## Proposal for amendments to Regulation No. 13-H reviewed during the 81<sup>st</sup> GRRF session

### I. Proposal

Annex 2,

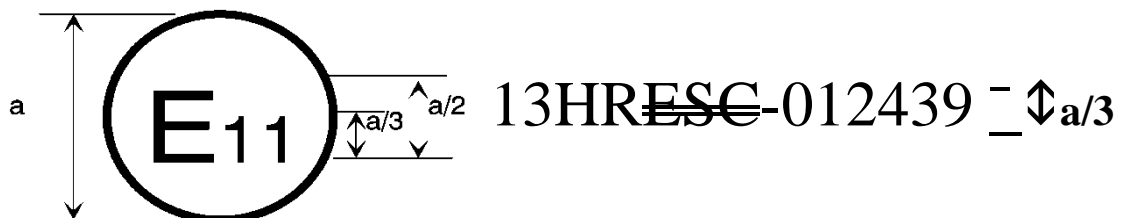
Approval mark and Paragraph of Model A, amend to read:

" The above approval mark affixed to a vehicle shows that the vehicle type concerned has, with regard to braking, been approved in the United Kingdom (E11) pursuant to Regulation No. 13-H under approval number 012439. The first two digits of the approval number indicate that the approval was granted

in accordance with the requirements of Regulation No. 13-H in its original form **01 series of amendments**. The additional marking "ESC" indicates that the vehicle meets the Electronic Stability Control and Brake Assist System requirements of Annex 9 to this Regulation. "

8. The example of the approval mark in Annex 2 should not contain any reference to ESC and should refer to the 01 Series of amendments.
